Korenix JetNet Industrial Managed Switch JetNet 4510 SOFTWARE RELEASE Notes

About This Software Version

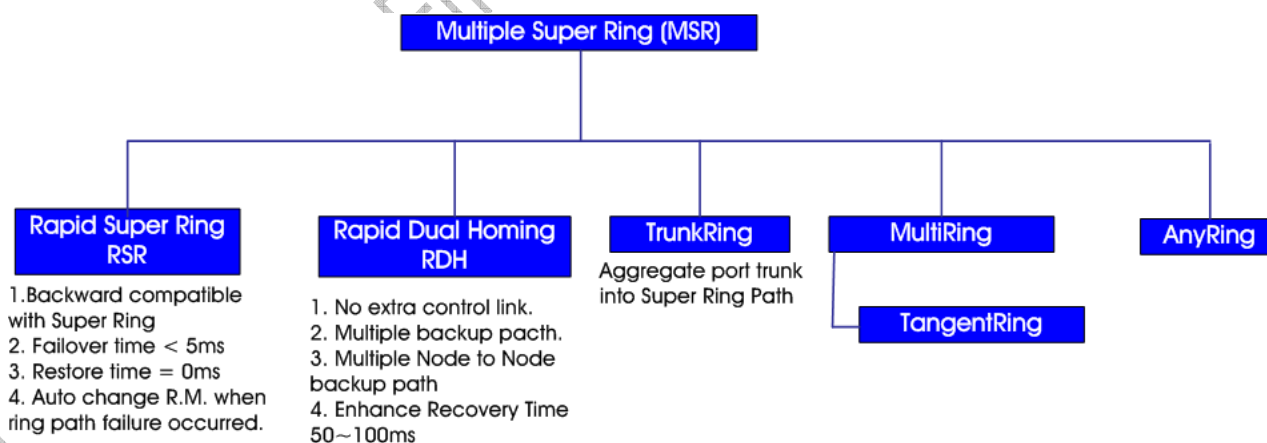
- Add DI warning event
- Armboot v 1.6.2.12 provides Menu UI and improve i2c access capability for DDM SFP
- Limits 2Mbps all frames to CPU, except PDU

- add relay function that the failure of Power 1 or 2 cause alarm in CLI mode
- Change \$PROMPT to 'switch#'

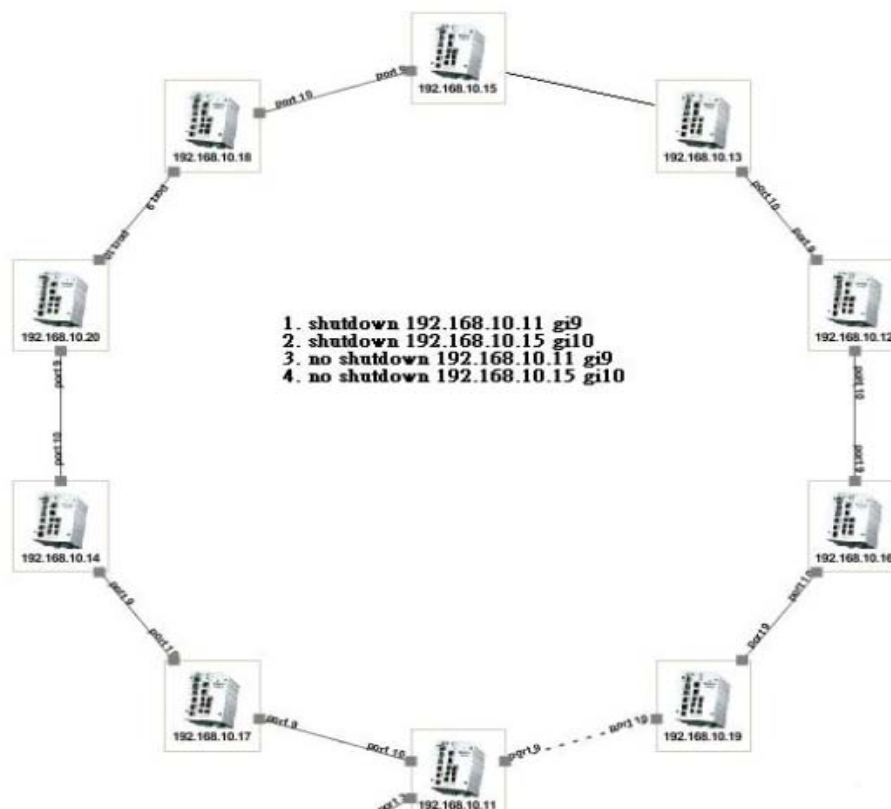
- Super Ring v2 can't run with LLDP function. (#1142)
- As the ring topology as below, link down /up active ring path will cause the ring status show "Abnormal" when this architecture working with JetView Pro for 2 days, also one of DUT will not be discovery by JetView Pro utility (# 1143,1144)
